CITY OF SAN BRUNO

ARCHITECTURAL REVIEW COMMITTEE
STAFF REPORT
AGENDA ITEM NO. 1.D
November 12, 2015

Request for an Architectural Review Permit to allow the construction of a new 67,586 square foot office building with 215 parking spaces per Chapter 12.108 of the San Bruno Municipal Code. NewGround (Applicant), San Francisco Police Credit Union (Property Owner).

SAN FRANCISCO POLICE CREDIT UNION NEW ADMINISTRATION BUILDING

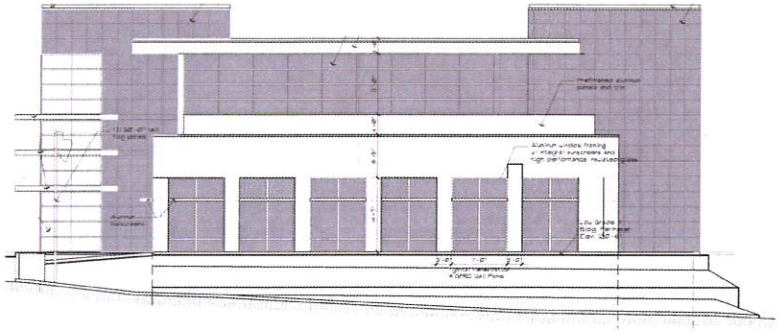
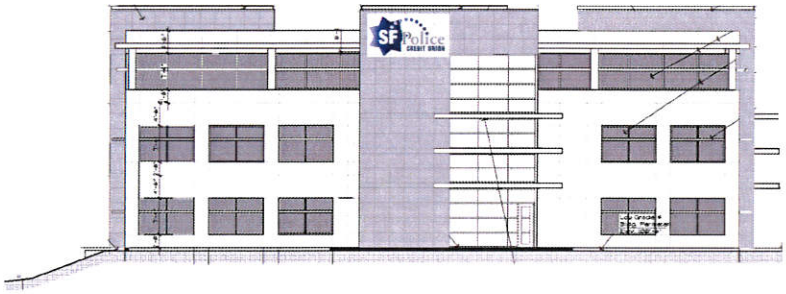
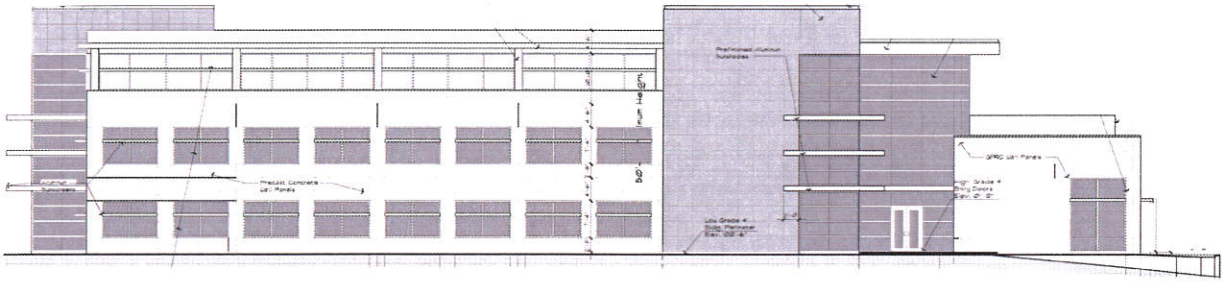
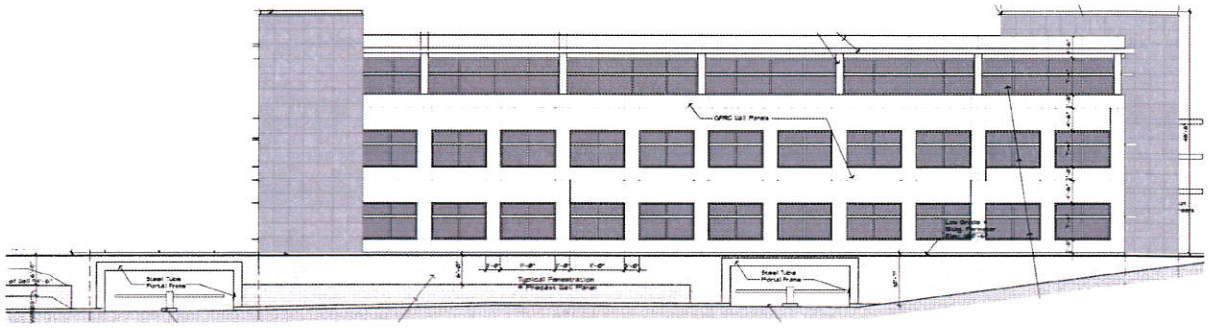
Overall, the design of the project is well done, and suitable to the neighborhood context. The design is contemporary in style, and utilizes a blend of high quality materials, as shown in the proposed elevations below.

The building elevations are good, and I have no recommendations for changes to them. There are a few site plan and garage issues that staff may wish to discuss further with the applicant.

SITE PLAN

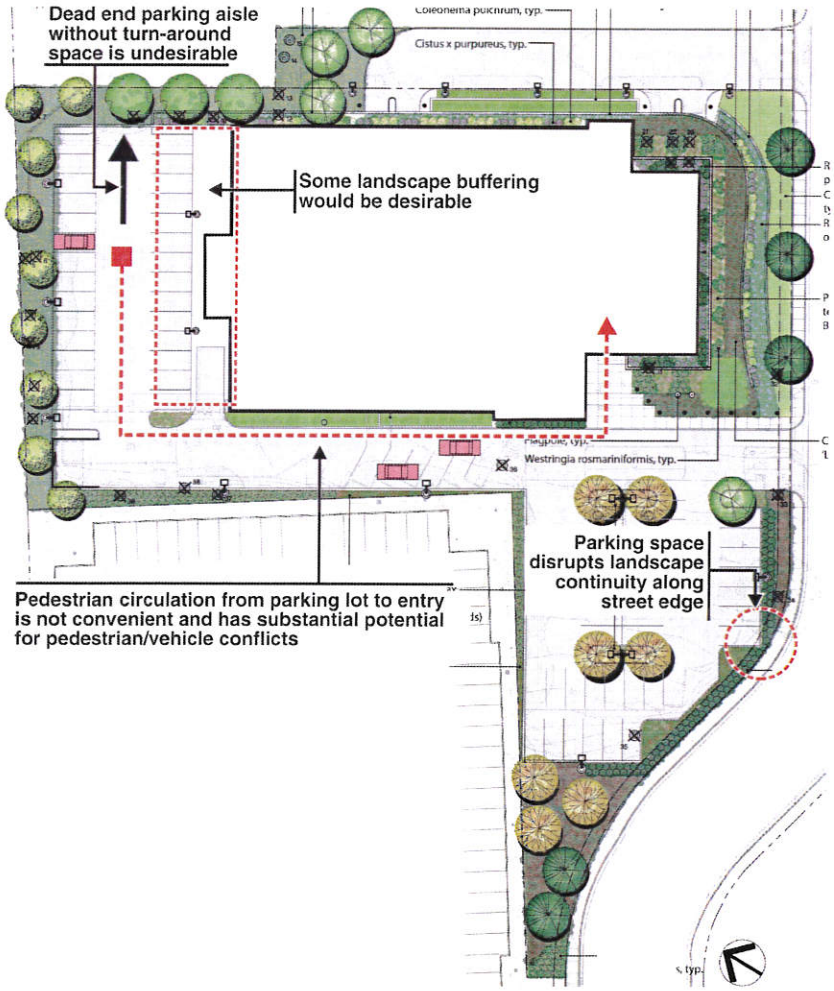
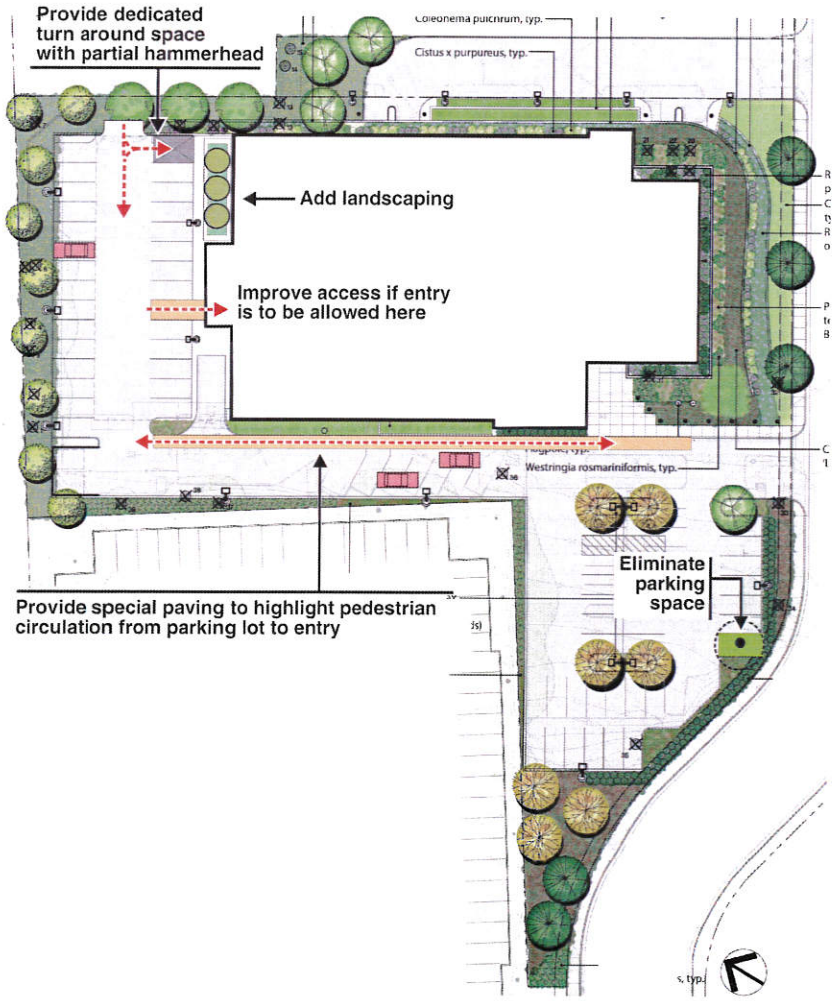
1. The parking immediately adjacent to Grundy Lane cuts into the landscaping between the sidewalk and the parking lot. In general, there appears to have been a strong effort in this office park to provide a sized green visual buffer between the parked cars and the street.
2. Pedestrian circulation between the north parking lot and the main building entry is not convenient, and has the potential for pedestrian/vehicle conflicts.
3. The dead end parking aisle in the north parking lot is undesirable unless all parking in the lot is reserved, and effectively signed to alert visitors since no turn-around space is provided.
4. Some landscape buffering would be desirable on the north side of the building.

2. Clarify where employees and visitors will park and how they will enter the building. Provide a pedestrian link through the line of parked cars immediately adjacent to the building, and provide a distinctly paved area with a minimum width of at least 4'-0" to set pedestrian movements apart from the moving vehicles. Given the limited space available, the pedestrian path will probably need to be at the same elevation as the driveway to maintain the minimum driveway width of 26'-0".

3. Provide a dedicated turn-around space at the dead end aisle in the north parking lot. Additionally, provide a partial hammerhead (5'-0" x 15'-0" minimum) at the eastern most edge of the north parking lot.

4. Add landscaping on the north side of the building. Since this area is over the parking structure, it would probably need to be in elevated planter areas.

GARAGE PLANS

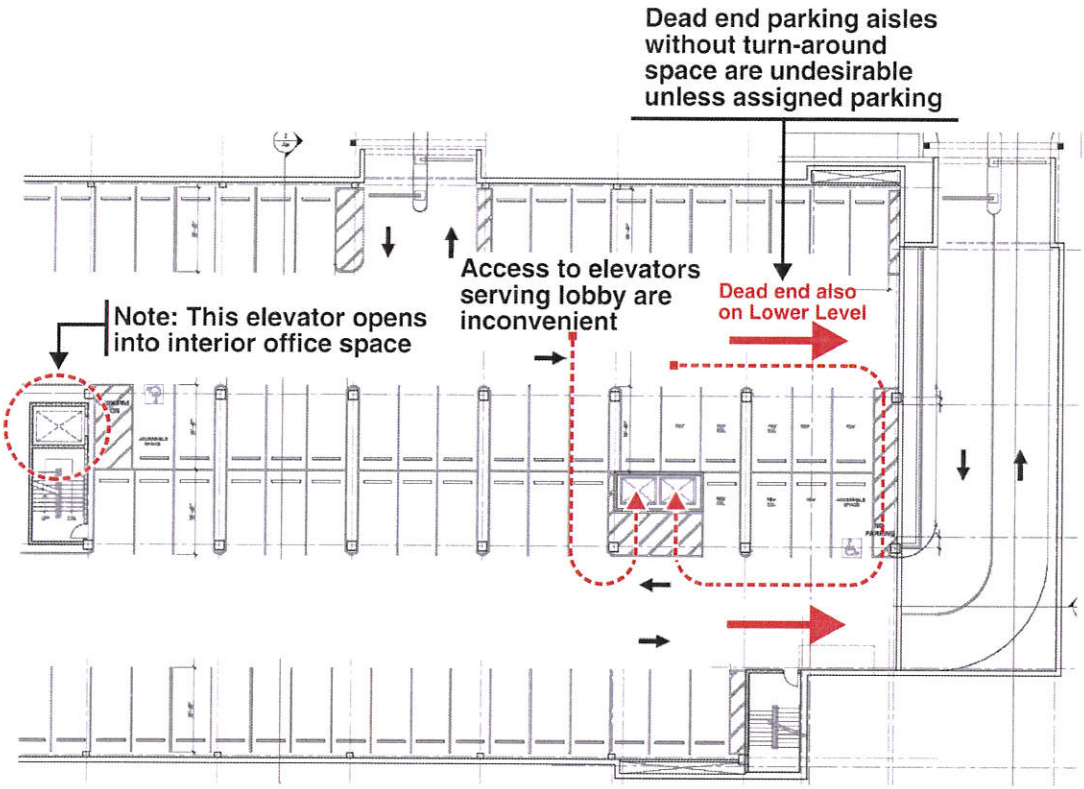
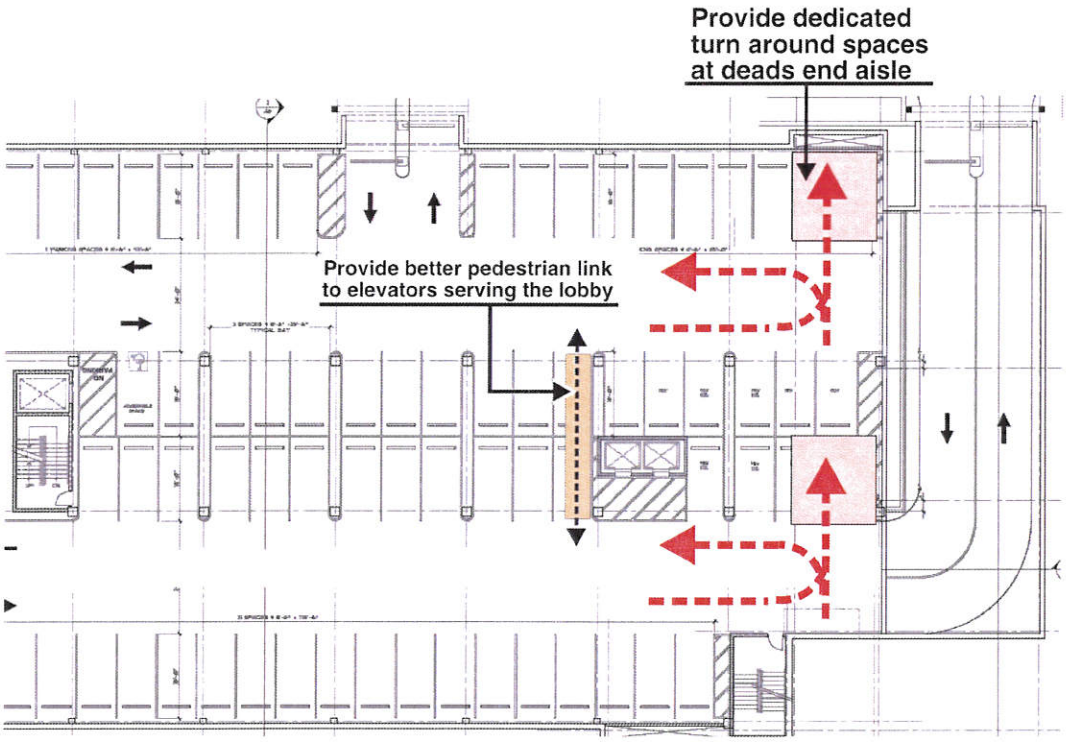
1. There are two dead end aisle on the upper parking level and one on the lower level. This would be very undesirable unless all parking along those dead end aisles were reserved spaces.
2. Access from parking spaces on the east side of the garage to the main elevators serving the building lobby is not convenient, requiring movement between parked cats or a long route to the end of the garage.
3. The elevator at the northerly part of the garage opens into the main work areas above. Some clarification as to who will use this elevator (i.e., employees only by key operation or also visitors to the building) would be desirable.

1. Provide dedicated vehicular turn around spaces at the end of all dead end drive aisles.

2. Provide a better pedestrian link between the spaces on the east side of the garage and the elevators serving the main entry lobby.
